Re: Laurel Canyon (Amendment)

**MDP# 761-B**

The City Staff Development Review Committee has reviewed the Laurel Canyon Development Plan, **M.D.P. # 761-B (Amendment)**. Enclosed, please find a signed copy for your files. Your plan was accepted with conditions as noted:

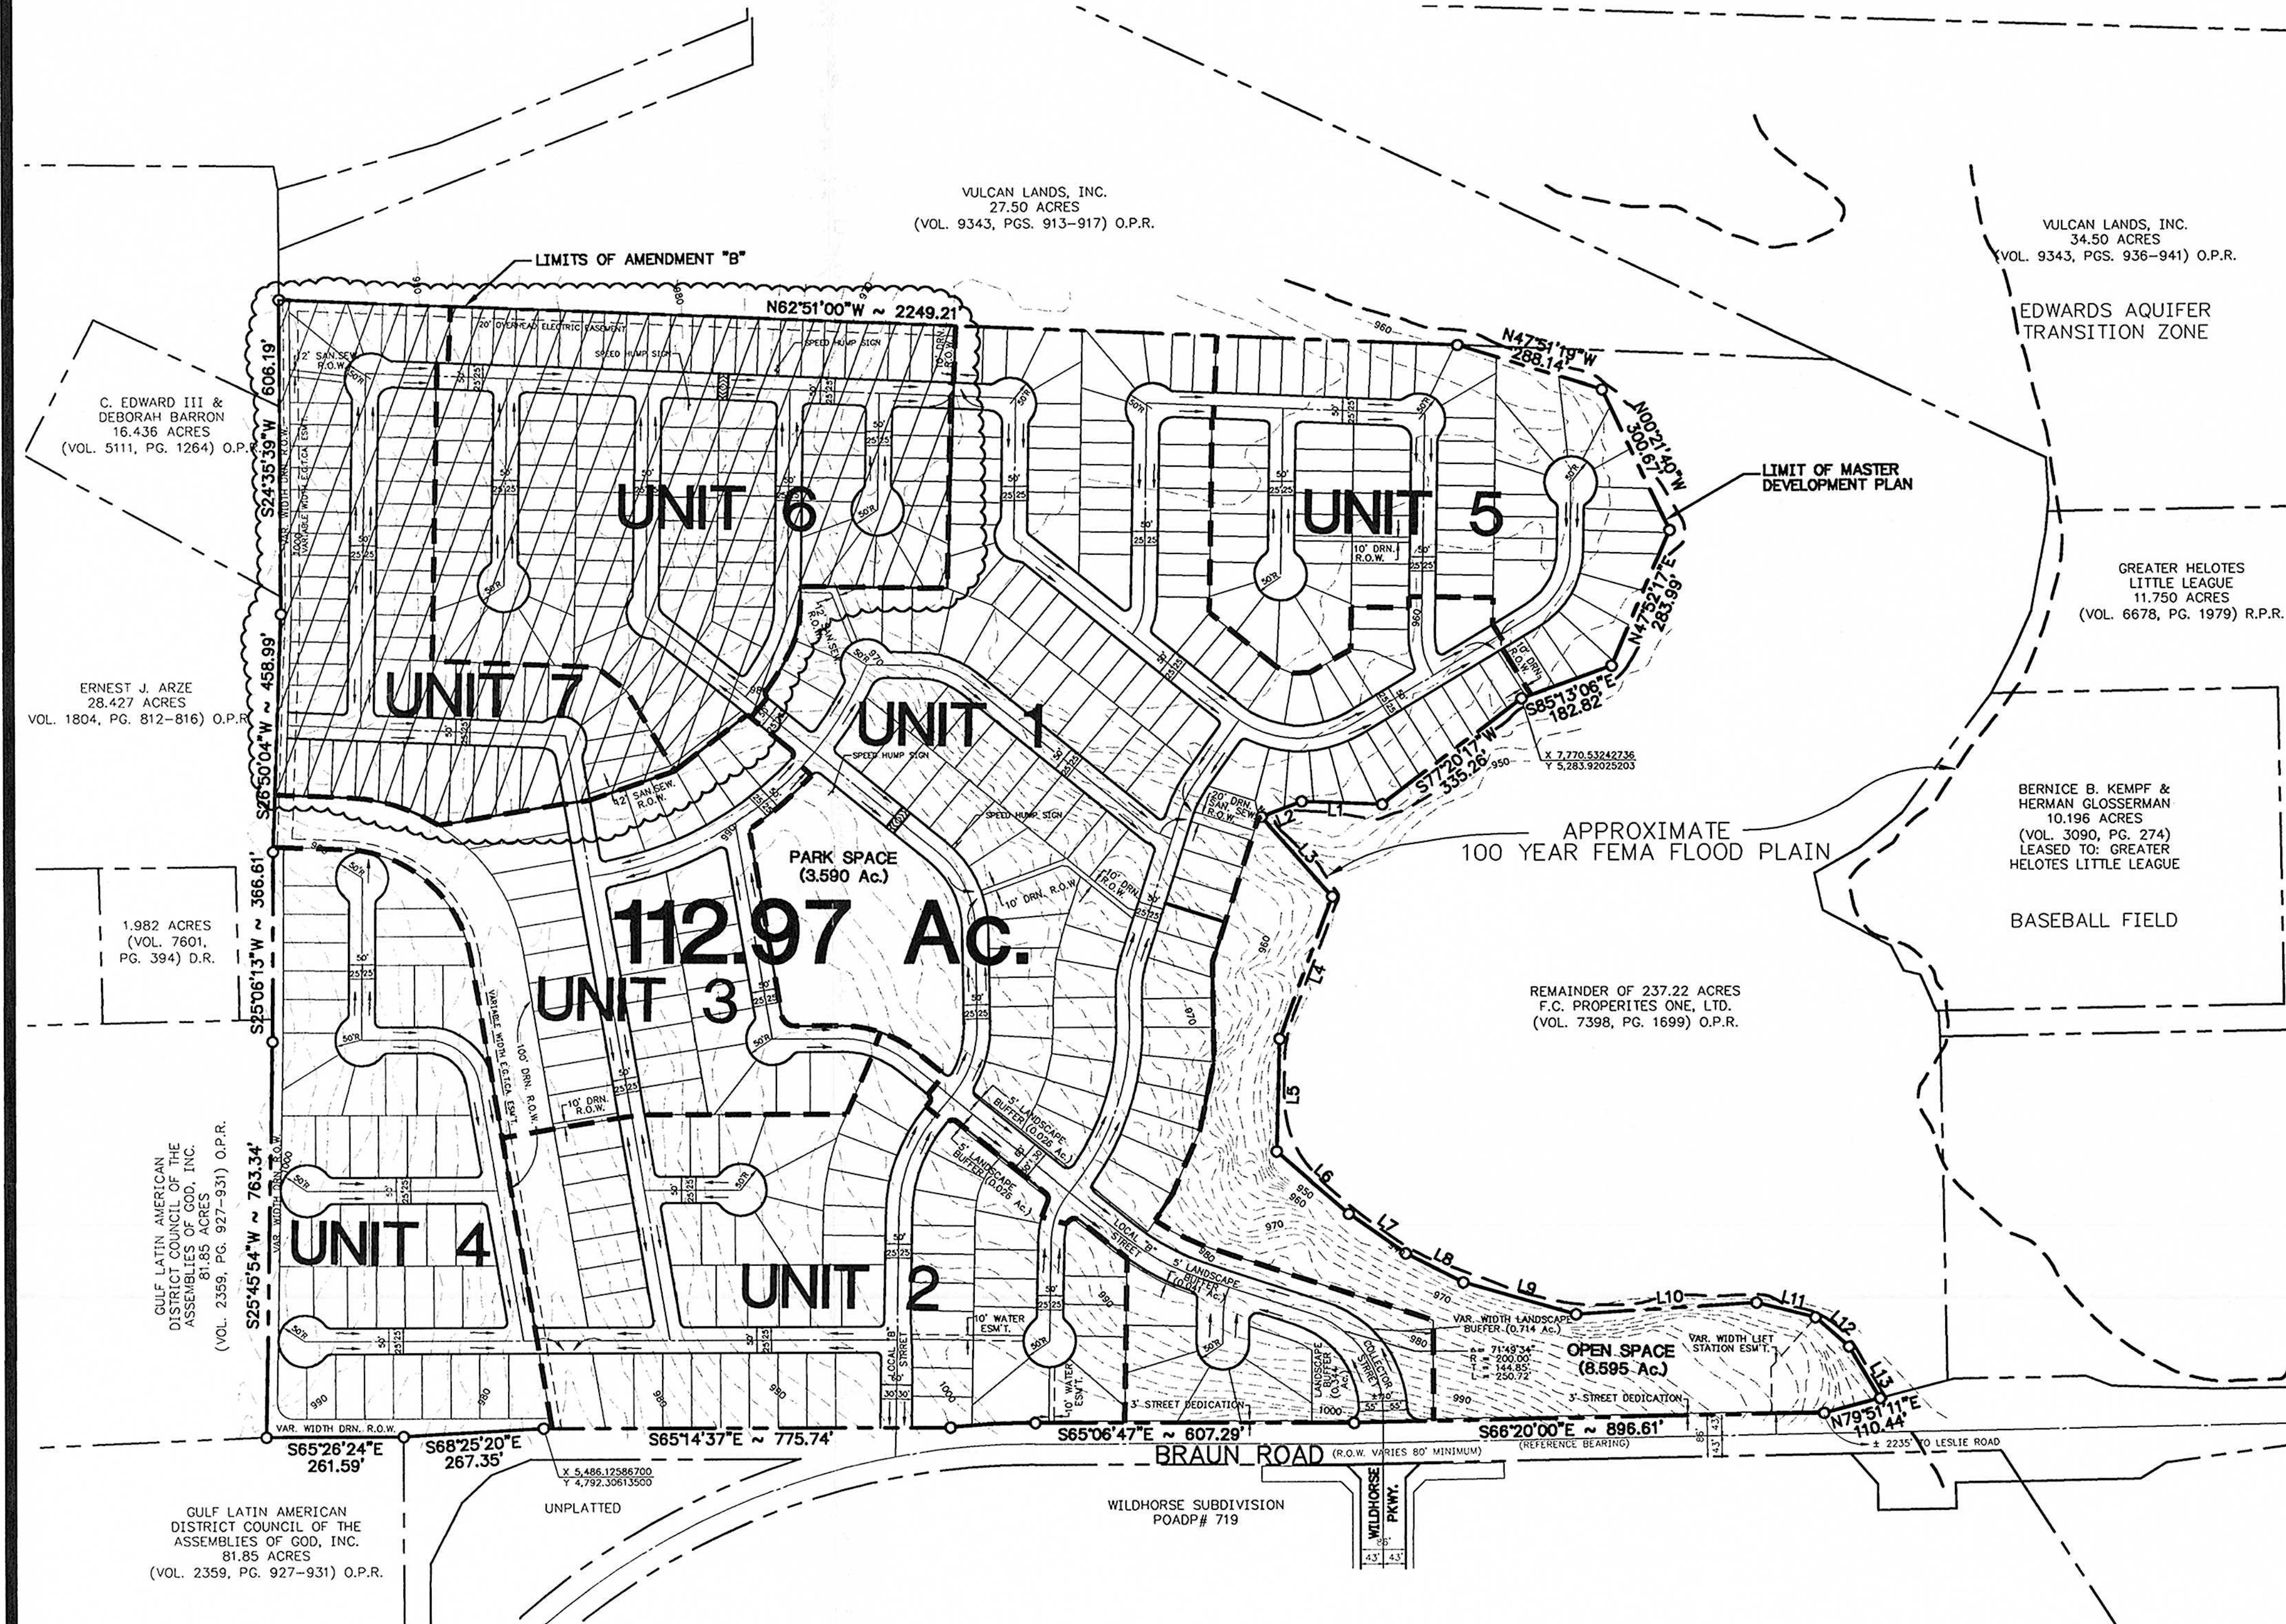
In our brief look at the plan, we saw several problems on the MDP. The liability for any damages caused by the subdivision to downstream properties and any damage caused to the subdivision itself due to drainage deficiencies, remain the sole responsibility of the developers of the property.

In our brief look at the plan, there are several concerns relating to traffic and the impact this subdivision will have on the surrounding area. Due to the deficiencies of the layout, any Traffic issues remain the sole responsibility of the developer of the property.

- In consideration of public safety and convenience, excessive grades by reason of topography should be avoided in street layouts and arrangements.
- This development will need to comply with tree preservation ordinance #85262. For information about these requirements you can contact Building Inspections at 207-7102.

Laurel Canyon is a subdivision of 529 units. Based on Section 35-503 of the UDC, the park dedication requirement for this development is 4.8 acres.

1. The 3.59-acre park designated "Park" on the plan be deeded to the Laurel Canyon Home Owner's Association (HOA). All requirements of 35-503(f)(2) are in force and required for this park.

2. Trees shall be planted parallel to all perimeter rights-of-ways. The distance between trees shall be an average of 32.5 feet with no distance greater than 50 feet. Each tree must have a minimum caliper of three (3) inches. Applicant may plant a minimum of two of the following species: Cedar Elm, Live Oak, or Monterrey Oak. Trees must be cared for and maintained by the developer for a minimum of one year.

3. The applicant shall install eight (8) picnic units and eight (8) park benches in the Park. Each unit must consist of a picnic table, benches, cement slab, and garbage receptacle. Tables and benches must be concrete or metal.

4. The applicant shall install an Open Play Area. This area is to be a minimum of 20,000 square feet of contiguous, unobstructed space with a maximum slope of five (5) percent. Common Bermuda shall be established in this area. The width of the play area must be a minimum of 100 feet.

5. The applicant shall install utilities to include security lighting and either irrigation for the care of the trees or a water fountain.
  6. The applicant has requested and will receive 1.50 acres credit for the installation of a jogging trail with a minimum length of 0.25 mile meeting the requirements of Table 503-4.

7. Park to be constructed and improved with the development of Phase 1 of the subdivision.
- It will be expected that you will plat all of the property depicted in your Master Development Plan (M.D.P.) to include floodplains, drainage areas and open space.

- For streets 1200' feet or longer, traffic calming is required.
